Access Compliance Report Public Rights-of-Way (Curb Ramps)

Main Street: SIENNA_PKWY		Cross Street: N_SELLAS_RD		Location:	W
ADA ID: RPRK211109125645	Ramp Type: Type 1 - Perpendicular	Initial Pass/Fail: Fail	Overall Compliance: No	Severity Score:	15

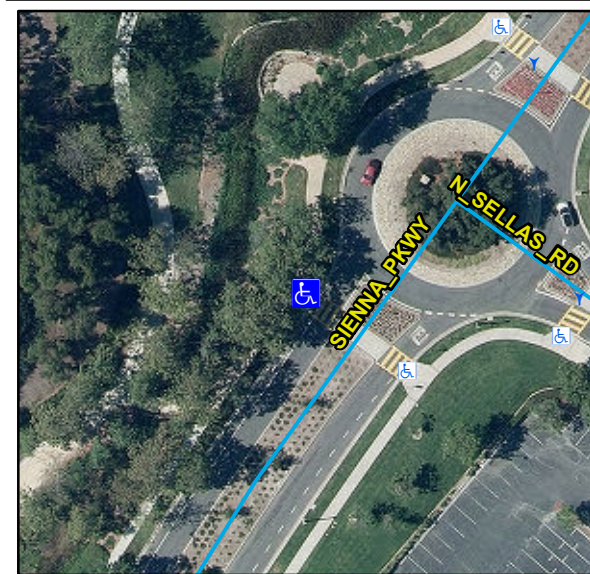
R304.2.2, R204.3, STD 1115

Remove & Replace Entire Ramp.
